COMMITTEE OF THE WHOLE JUNE 7, 2004

**ZONING BY-LAW AMENDMENT FILE Z.04.016
SITE DEVELOPMENT FILE DA.03.053
1541677 ONTARIO LIMITED**

Elevations - North

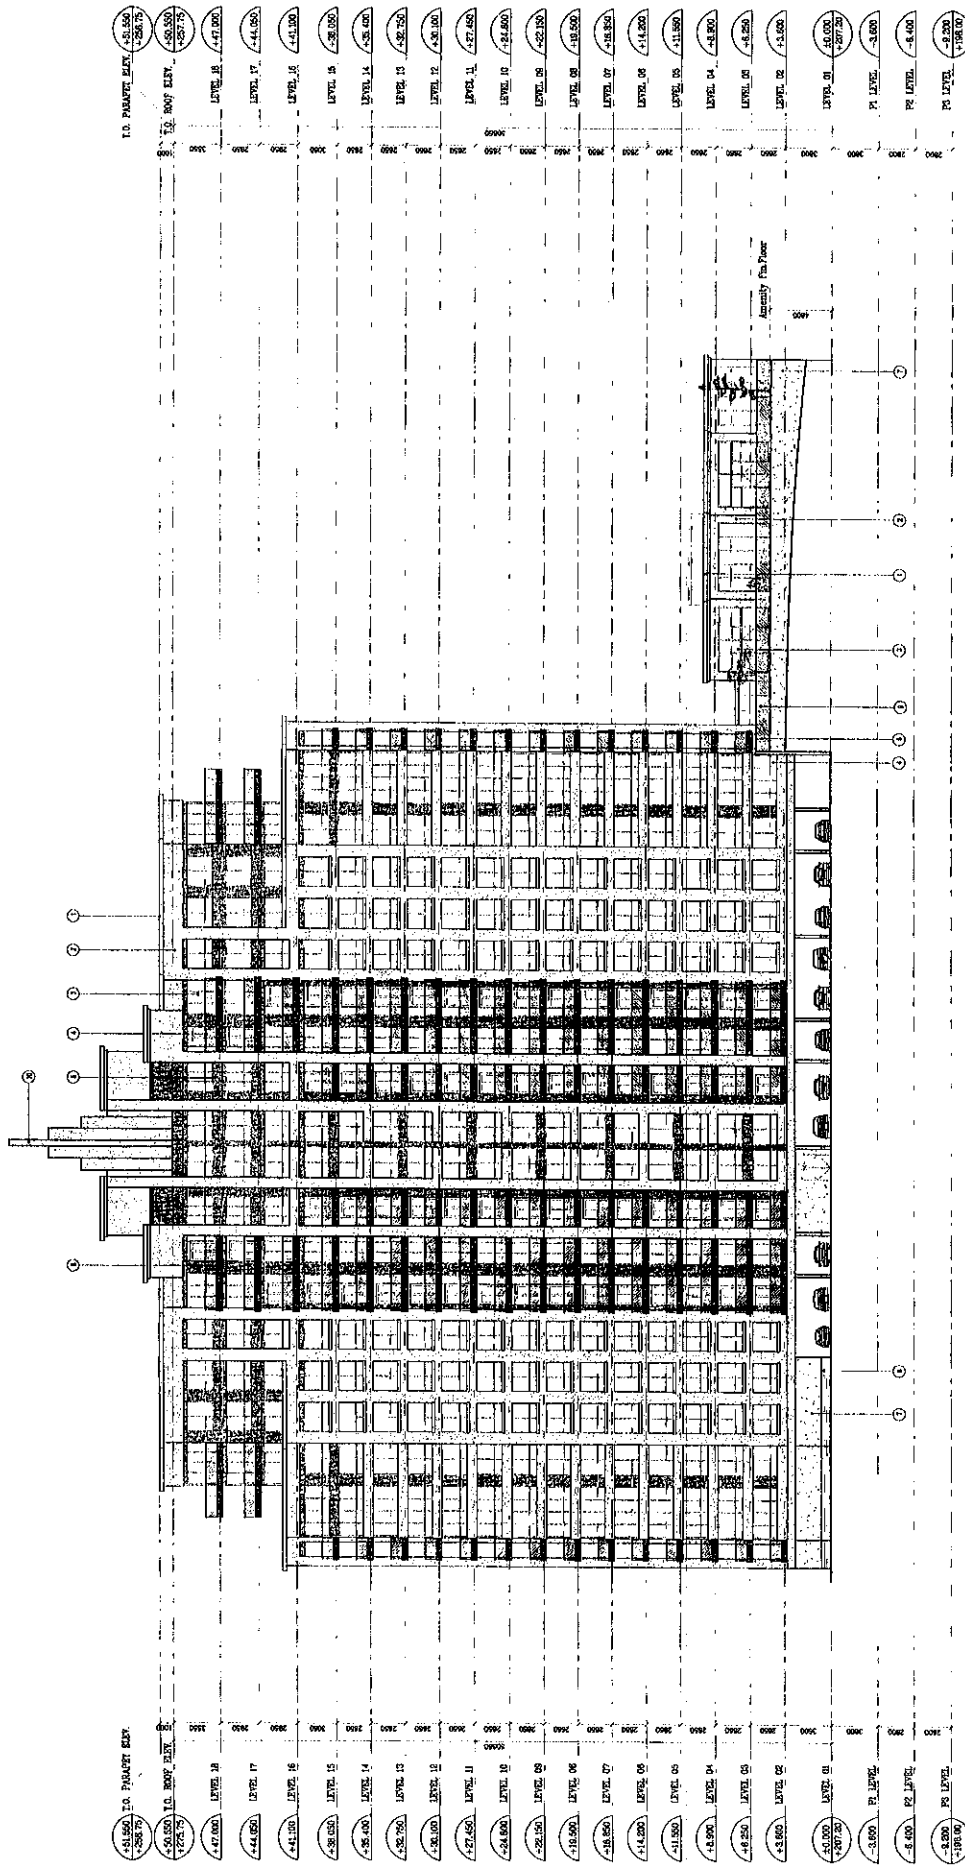
The Urban Design Department has requested that the elevation plans clearly show the ground floor suite entry/exit doors.
